Product Change Notification - SYST-01VKOT288

ERRATA - PIC32MZ Embedded Connectivity with Floating Point Unit (EF) Family Silicon Errat

PIC32MZ Embedded Connectivity with Floating Point Unit (EF) Family Silicon Errata and Data Sheet Clarification

FIGURE 1: POSC CRYSTAL CIRCUIT

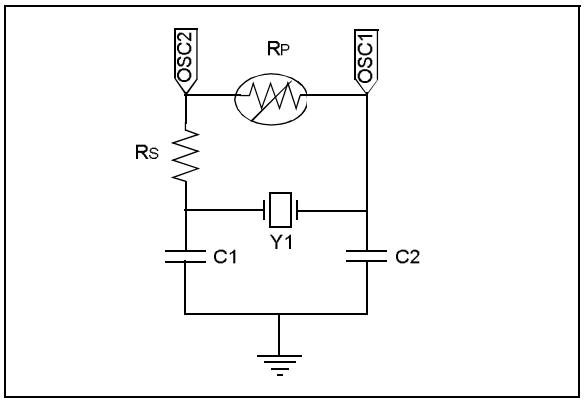
Revision A1 Silicon: A crystal oscillator cannot be used as an input to the Primary Oscillator (POSC) pins OSC1 and OSC2.

Revision A3 and B2 Silicon: The POSC has been tested in a normal power-up sequence and supports specific crystal operation.

Updated Figure 1 and Table 3 in silicon issue 2. Module: (Oscillator).

Silicon Work around 1

The Primary Oscillator (POSC) has been characterized to operate at 8 MHz, 12 MHz, and 24 MHz when the circuit in Figure 1 is implemented, and the operating conditions listed in Table 3 are met.

Silicon Work around 2

Alternatively, use an external clock or the Internal FRC oscillator.
